# CITY OF ALBUQUERQUE

**RE: Chama Street Affordable Cottage Development  
Grading and Drainage Plan  
Engineer's Stamp Date: 10/24/2025  
Hydrology File: K19D157  
Case # HYDR-2025-00384**

Based upon the information provided in your submittal received 10/24/2025, the Grading & Drainage Plan is **not** approved for Grading Permit, Building Permit, SO19 Permit or WO. The following comments need to be addressed for approval of the above referenced project:

CHAMA STREET AFFORDABLE COTTAGE DEVELOPMENT  
 161 CHAMA ST. NE  
 ALBUQUERQUE, NM 87108

**GRADING PLAN**

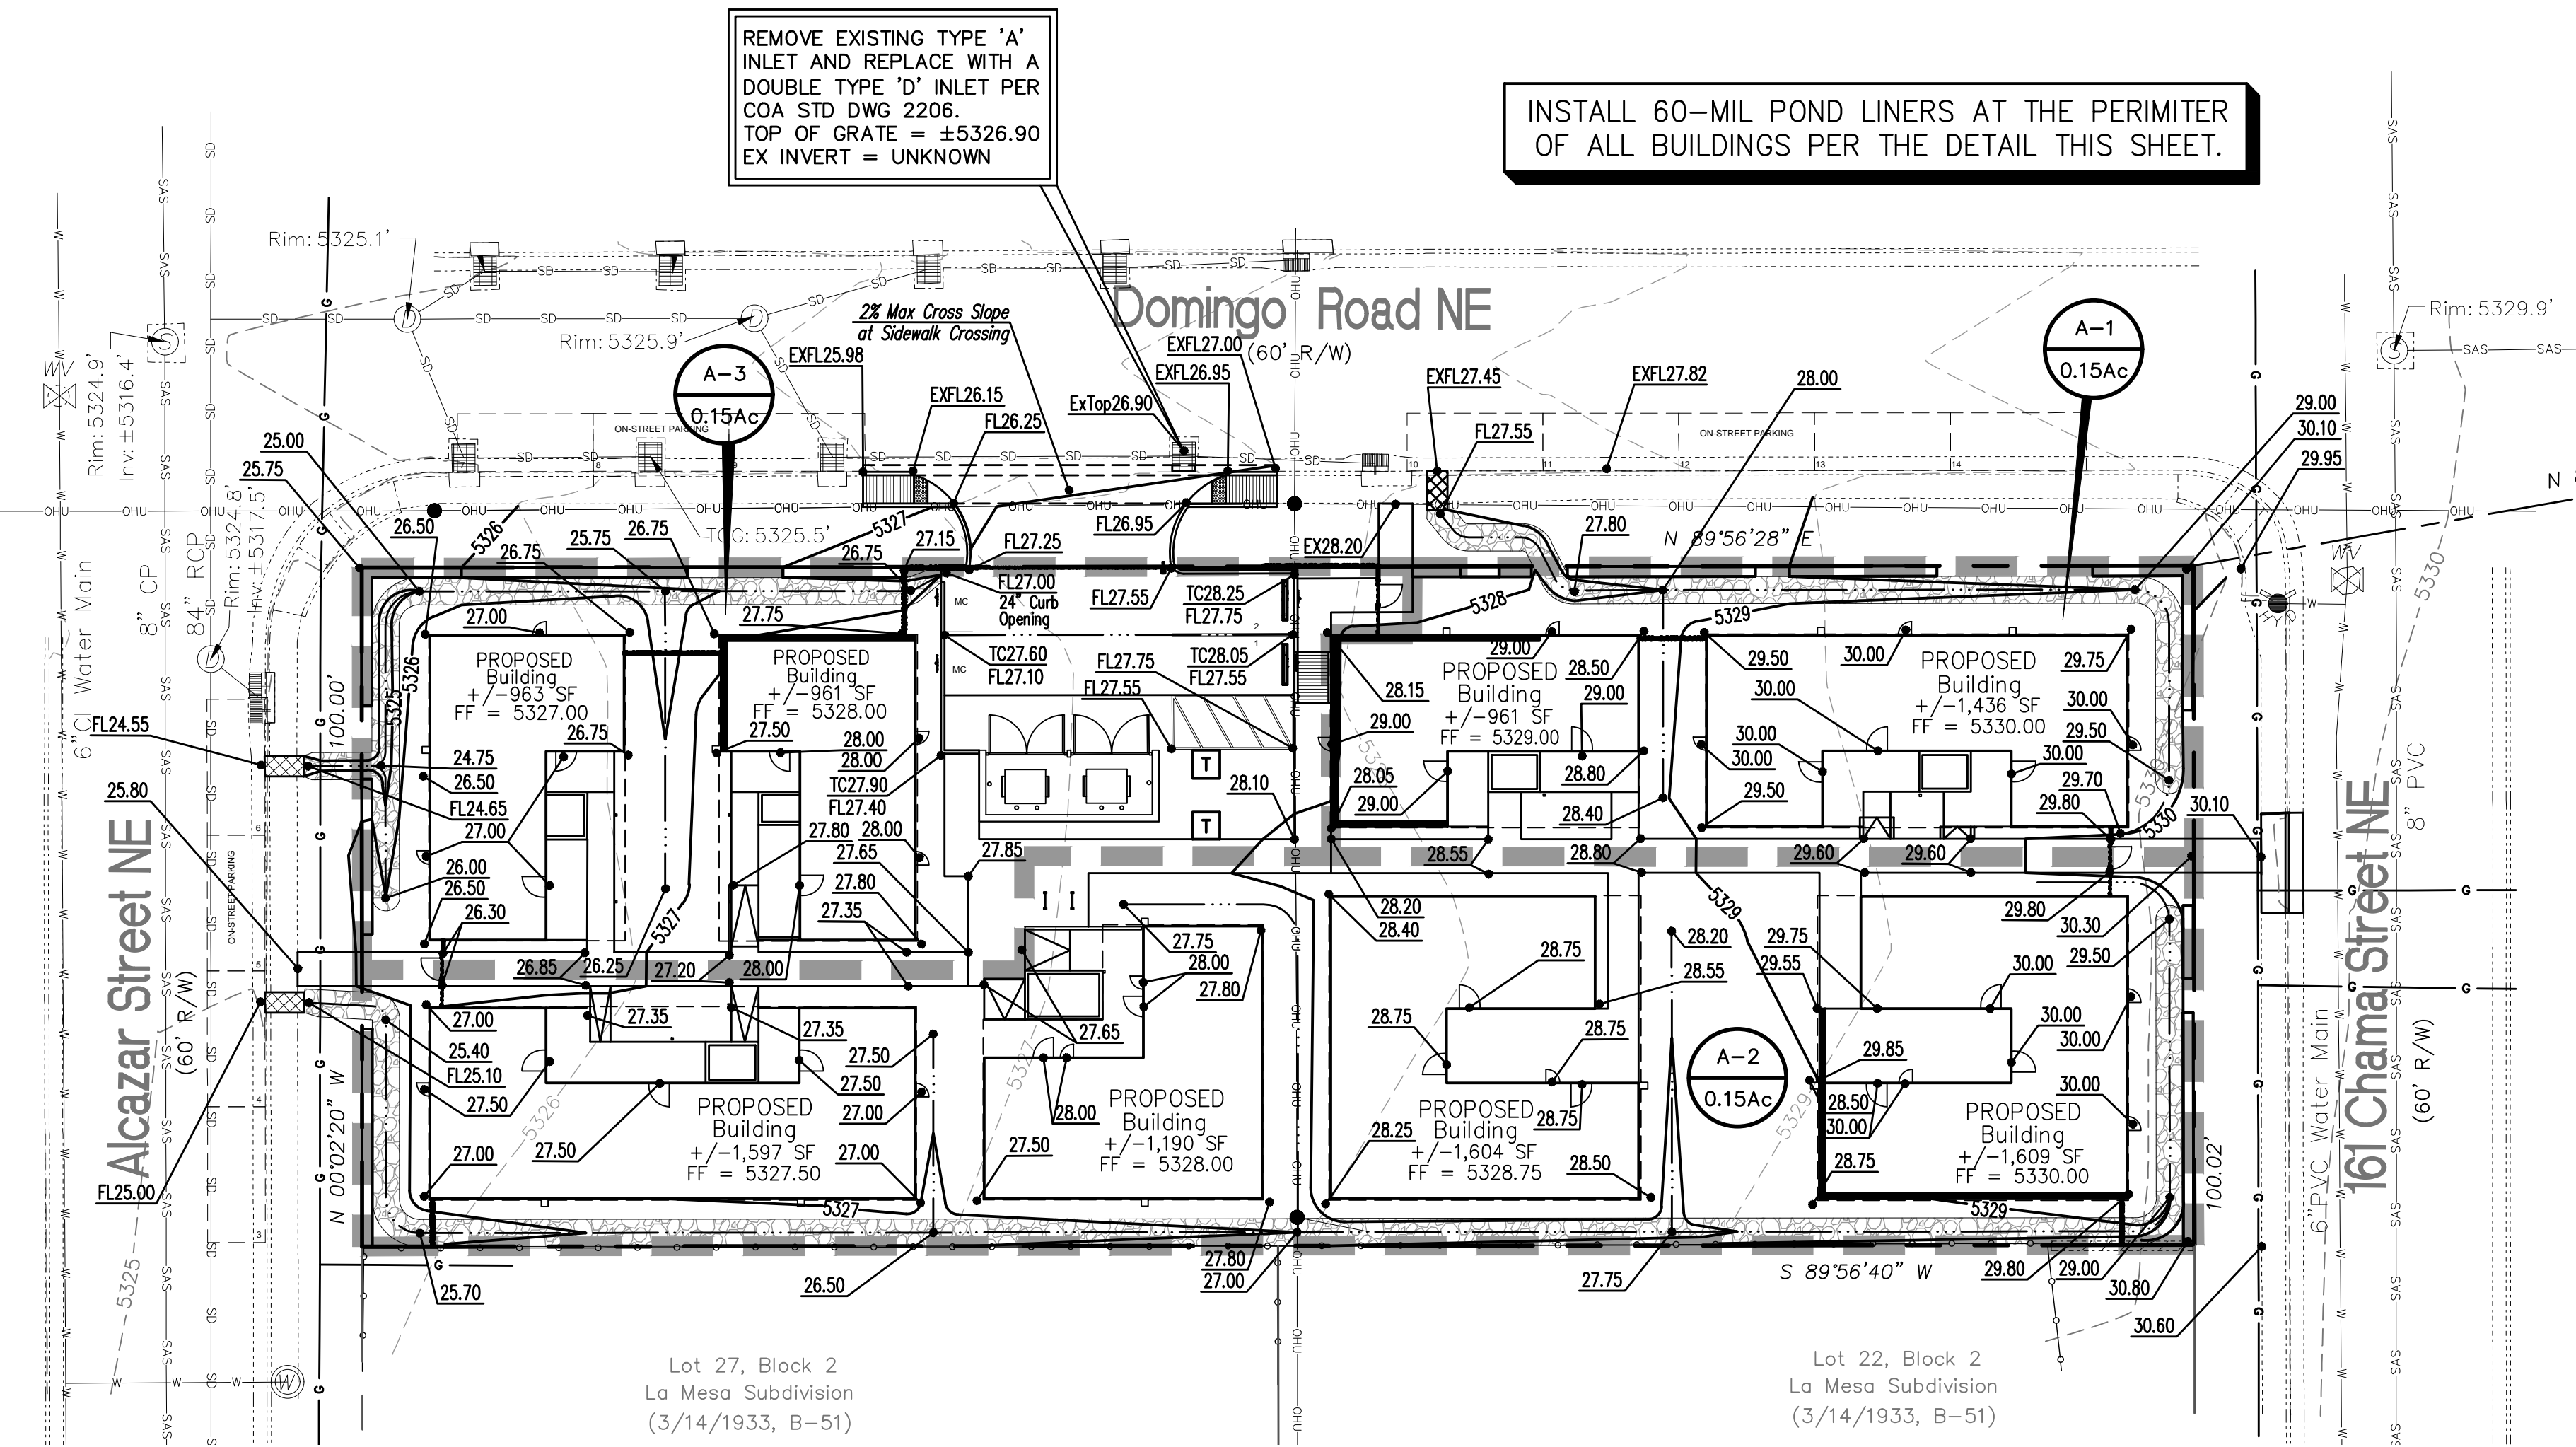
1. Per Part 6-6(D) of the DPM: For development adjacent to or in an unnumbered A Zone, the base flood elevation (BFE) will be determined by best available data. If no data are available, the BFE is considered to be 2 feet above the highest adjacent grade. Please show the SFHA Zone A on the plan and state the determined BFE that will be used for the SFHA adjacent to the development.

2. Ensure that the lowest finished floor elevations are designed to be 1 foot above the BFE.
3. Add a note to the plans that due to the adjacent SFHA Zone A, a Pad Certification is required for Hydrology verification prior to approval for Building Permit. The required Engineer's Certifications should also be noted on the Infrastructure List.

4. Drainage Narrative – Please add mention of the adjacent SFHA Zone A along the east and north perimeter of the site.
5. An SO-19 Permit will be required and should be included on the request. Please include the [standard SO-19](#) notes on the grading plan.

6. Please call out the sidewalk culverts on the plan and reference City of Albuquerque standard detail No. 2236 – Sidewalk Culvert with Steel Plate Top at the sidewalk culvert.

7. Provide management onsite for the Stormwater Quality Volume (SWQV) in accordance with the new drainage ordinance, § 14-5-2-6 (H). **Please show the top and bottom of the ponds along with the volume for each pond.** The onsite drainage should be directed to these ponds prior to being collected in a private unground drainage system. Please follow the DPM Article 6-12 Stormwater Quality and Low-Impact Development for the sizing calculations. To calculate the required SWQV, multiply the impervious area draining to the BMP by 0.42 inches for new development sites and 0.26 inches for redevelopment sites. The calculations of both the required and the provided volume of

each BMP must be shown on the Grading and Drainage Plan. **Each BMP should be labeled on the Grading and Drainage Plan with the required SWQV and associated water surface elevation and the 100-year water surface elevation. Landscaping of surface BMPs is also required to be noted on the Grading and Drainage Plan.**
